RCA-18-22-002-1: Replace Rear Upper Lateral Links and Fasteners

Document Type	Customer Satisfaction Campaign Bulletin
Date	June 8, 2022
Affected Region(s)	USA
Affected Model(s)	R1T
Model Year(s)	2022
Approximate Build Dates	August 2021 - December 2021
 Refer to the FSA Dashboard to determine if this document applies to a specific vehicle.	
Vehicle System	18 - Suspension
Minimum Service Location	Service Center

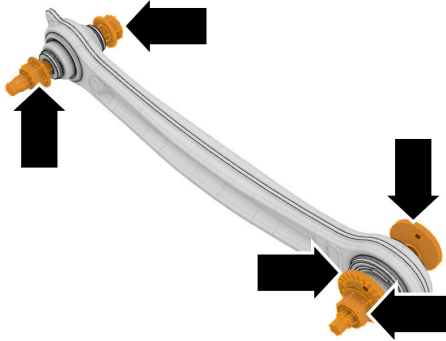
1. On both sides: Replace: Link, Lateral, Rear, Upper, LH (refer to service manual procedure 183215010).

Note: Replace the highlighted component(s).
